DEVELOPMENT ASSESSMENT CASE NUMBER: CD-2019-0006 – 614 S. 1st Street PUD

Presentation of a Development Assessment Report for the 614 South 1st Street Planned Unit Development (PUD), located at 614 South 1st Street, within the East Bouldin Creek Watershed.

The staff’s comments on the applicant’s development assessment submittal for this proposed PUD project were completed on November 6, 2019 and is compiled in the Master Report, see *Exhibit H: Master Report*.

SHEET TITLE: **LAND USE PLAN**

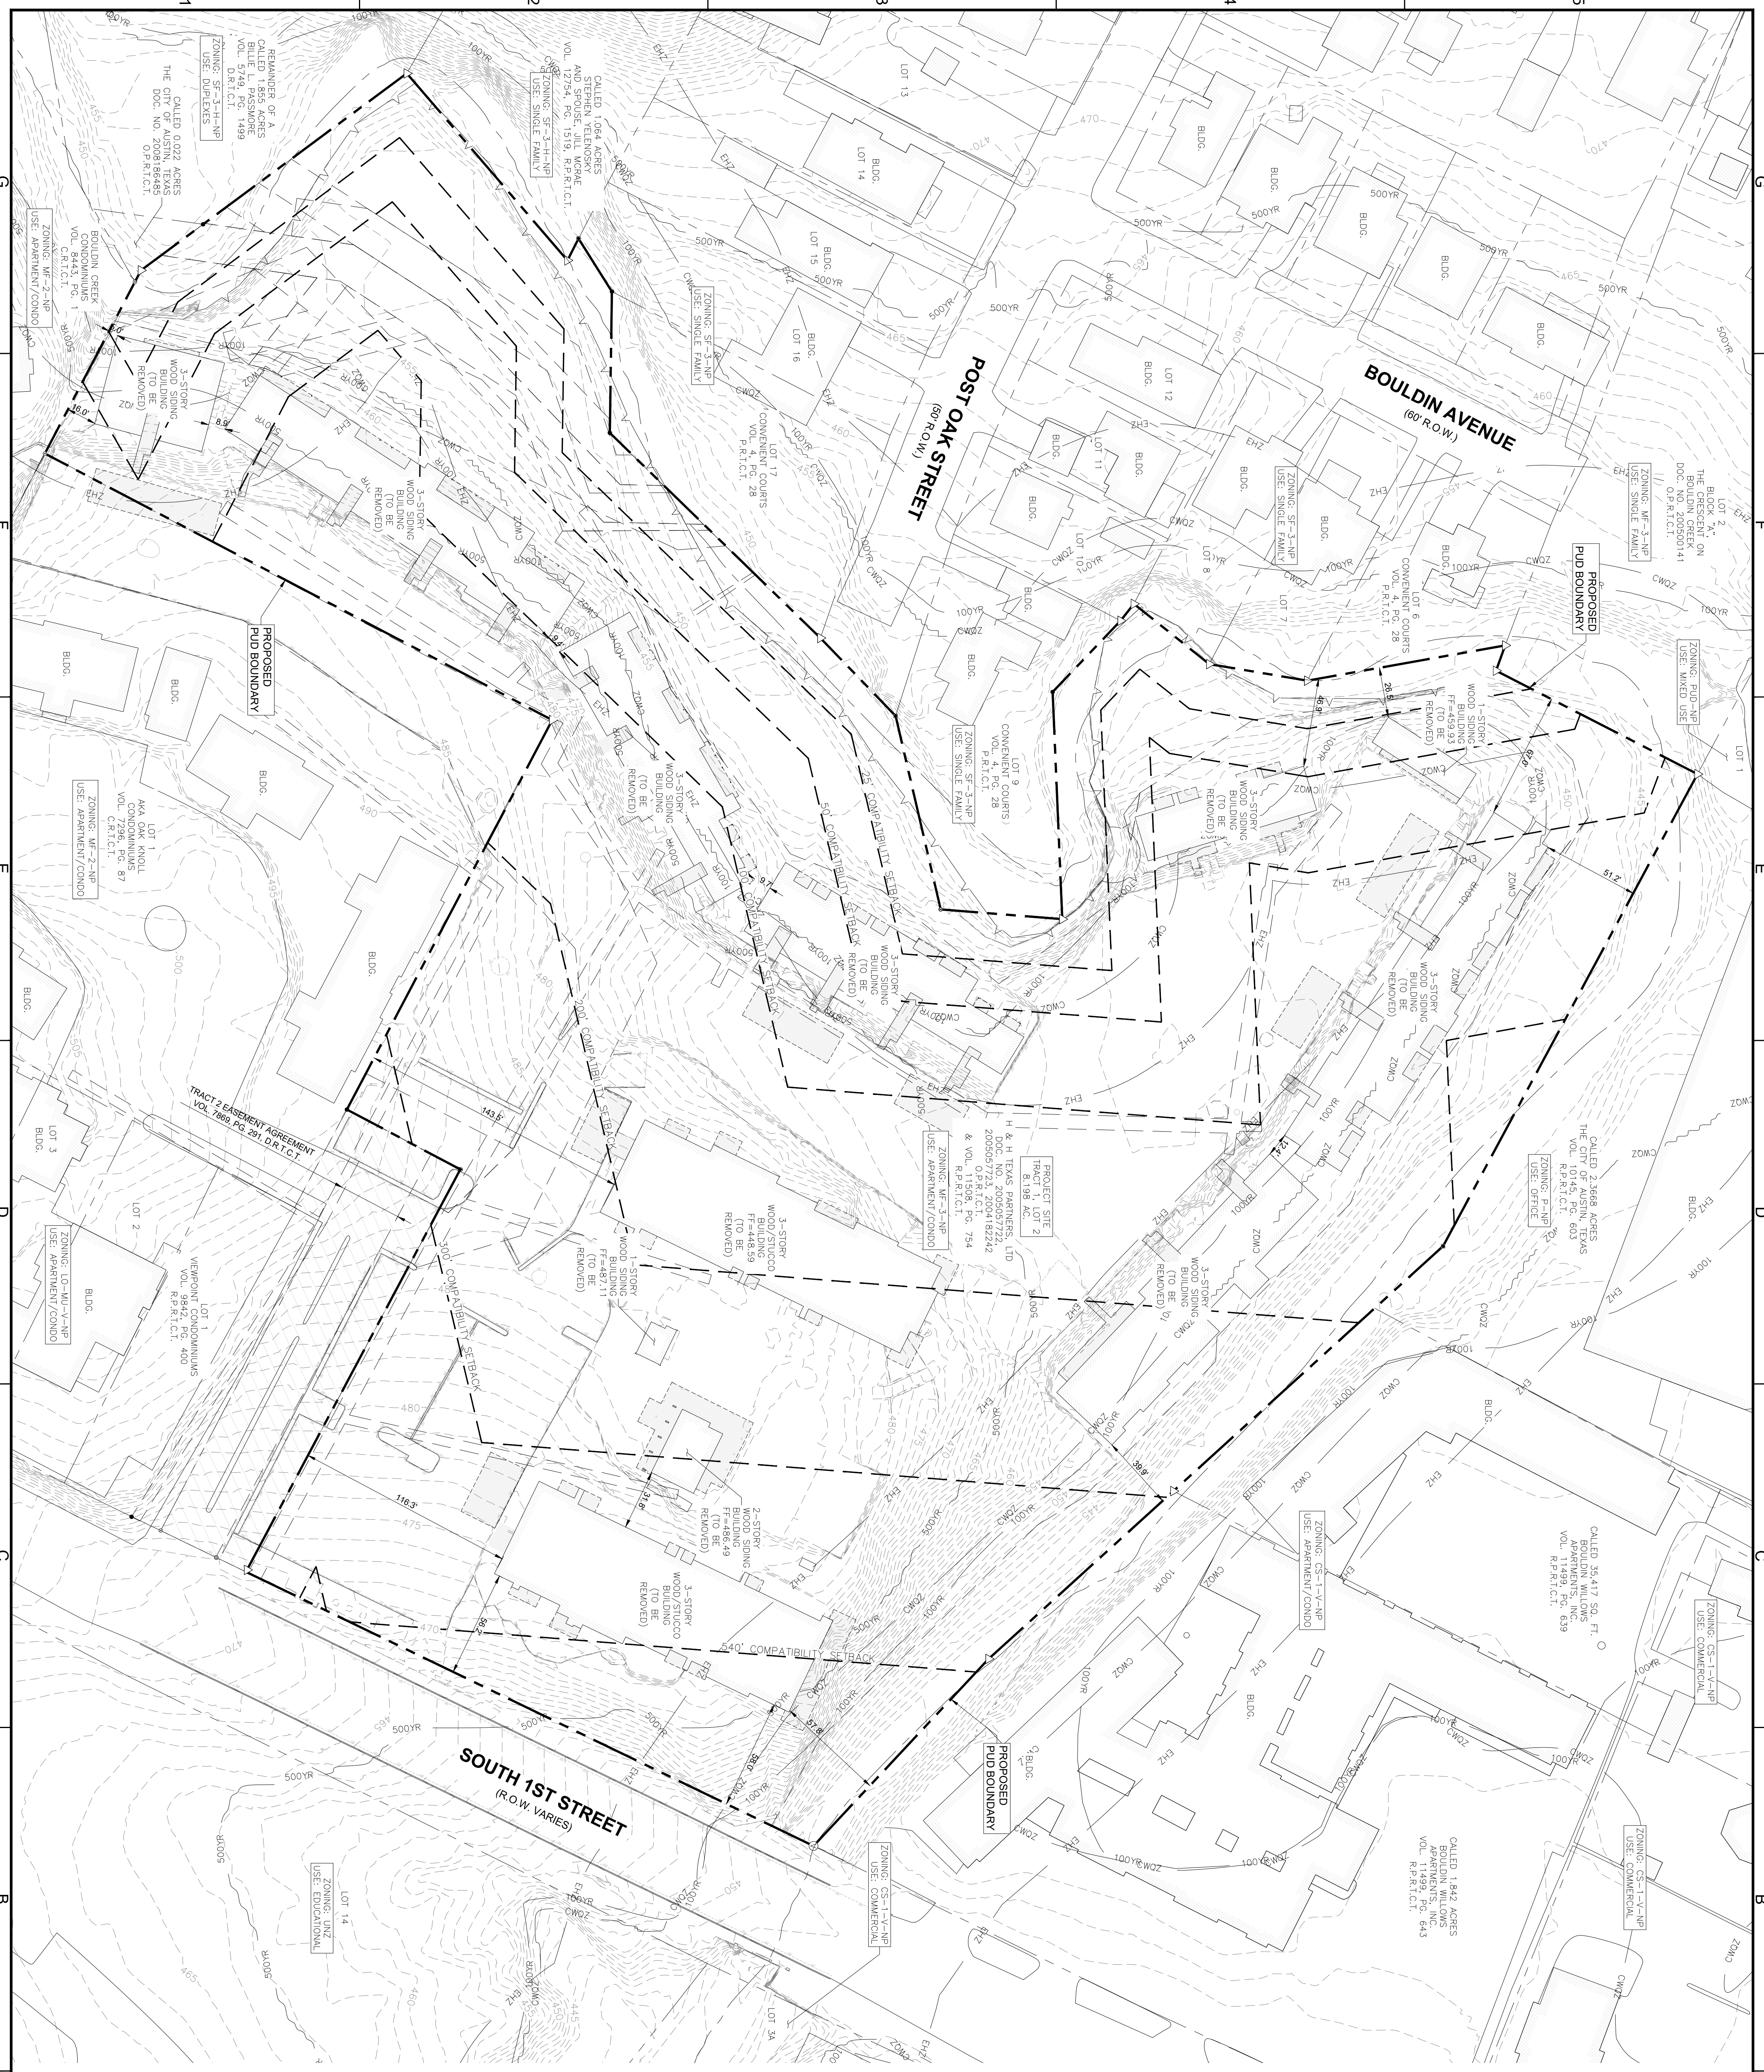
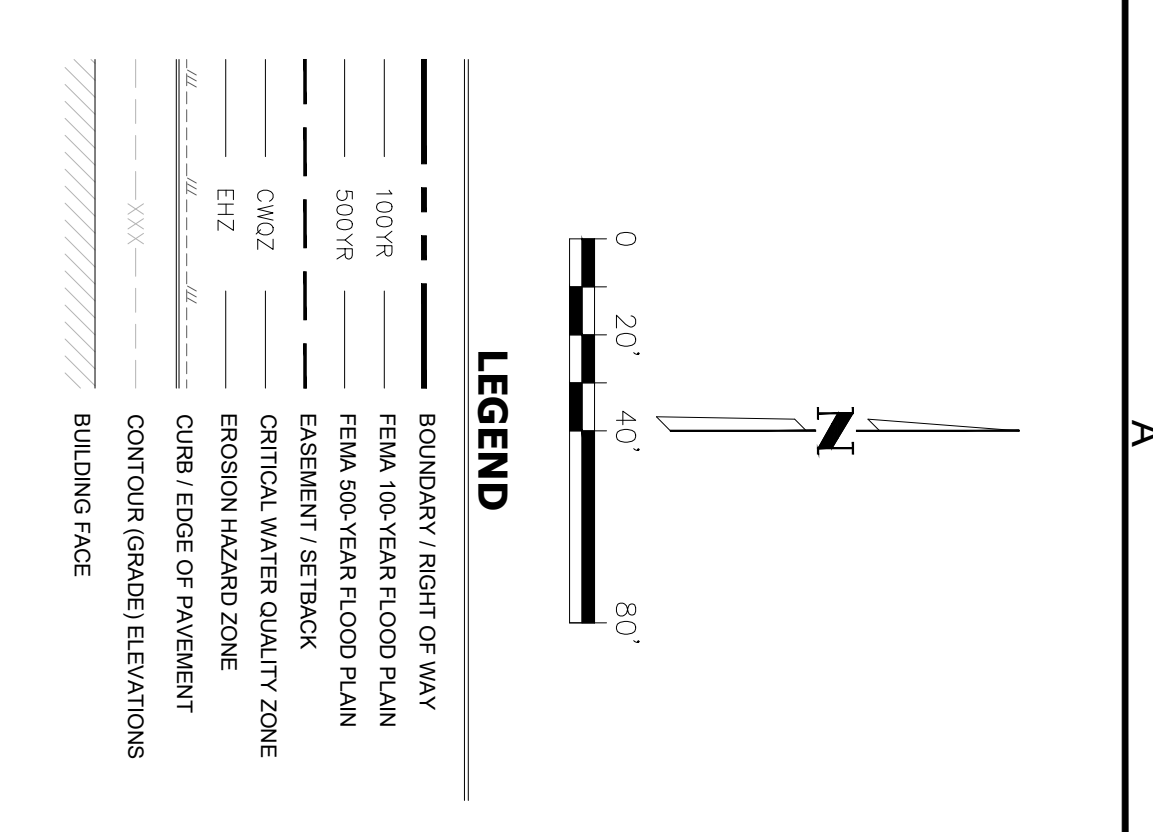
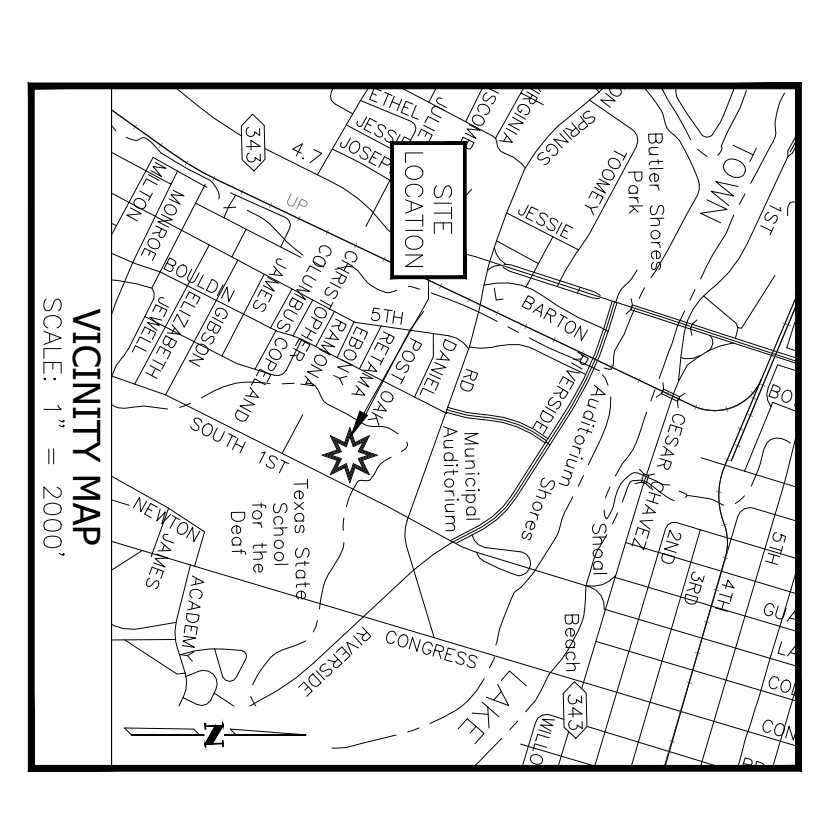
- EL 1. Within the baseline site development regulations table for minimum setbacks, the following note needs to be added to the Land Use Plan:

“Electrical easements shall be required for all developments. Their location and size onsite will be determined at the subdivision plat/site plan submittal and may require more space than minimum building setback.”

- EO 2. Please show the current FEMA 500-year floodplain on the Land Use Plan.
- EO 3. Per 25-8-92(C), an urban waterway is defined by the floodplain or an offset of 50' from the centerline of the creek, please use this guideline to define the critical water quality zone.

- EO 4. Show the potential open space and provide the acreage. If providing parkland and open space, show where each is located and provide the acreage.

- ZN 1. Please provide an updated, *Land Use Plan* with the PUD application containing the following:
- The overall land area divided into tracts with corresponding acreages and land uses (e.g. open space, residential, mixed use, etc.) clearly identified;

- Exclude existing features to be removed and associated dimension lines/notes within the proposed PUD boundary for readability;
 - Exclude or grey back all other existing features and associated dimension lines/notes from the Land Use Plan for readability;

- Grey back existing contour elevation lines from Land Use Plan for readability;
 - Remove *Baseline Allowable Use* from the Land Use Plan, see Comment ZN 5.

- ZN 3. On the Land Use Plan or as a separate exhibit with the PUD application please provide a summary table showing the proposed development standards (e.g. minimum lot size, minimum lot width, maximum height, minimum setbacks, maximum number of units or maximum building coverage, maximum impervious cover and/or maximum FAR) for all tracts within the PUD boundary. Staff will consider the height request of 120’ when additional information is provided at the time of PUD application.

- ZN 5. If current MF-3 permitted, conditional or prohibited uses are not changing with proposed PUD, the *Baseline Allowable Uses* chart is unnecessary, please remove. If the proposed PUD will modify the existing uses, please provide a *Land Use Chart* as a separate exhibit to identify all permitted and conditional uses with the PUD boundary.
